TECHNICAL BULLETIN

File No.:	TB-9623 (1 of 2)	Date:	6-24-96
Model:	FT-1000MP	Serial No. Range:	Problem Unit

Problem:	Keyer IAMBIC 2, having problem
----------	--------------------------------

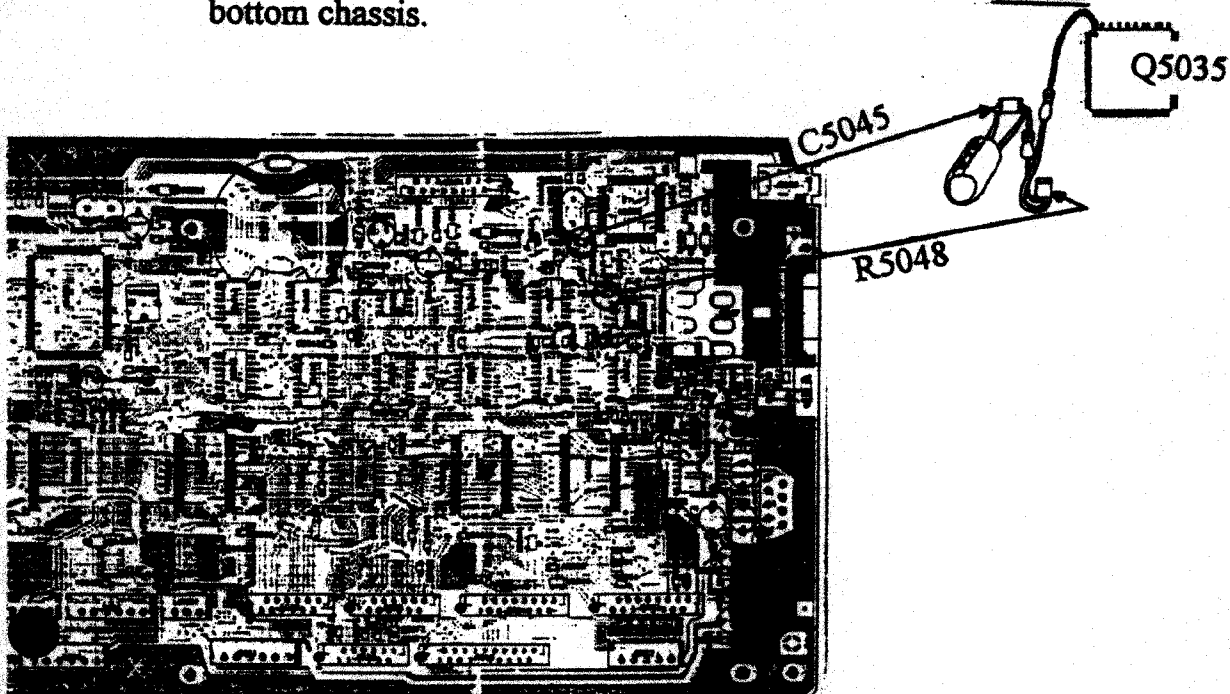
Expected Results of Modification:	Improve circuit performance #2
-----------------------------------	--------------------------------

Component Changes: Control Unit			
Part Location No.	From	To	New Part No.
C5084	K46120002	Replace	K46120005
R5131	100ohms	22ohms	J01225220
Resistor	ADD	3.3Kohms	J01225332
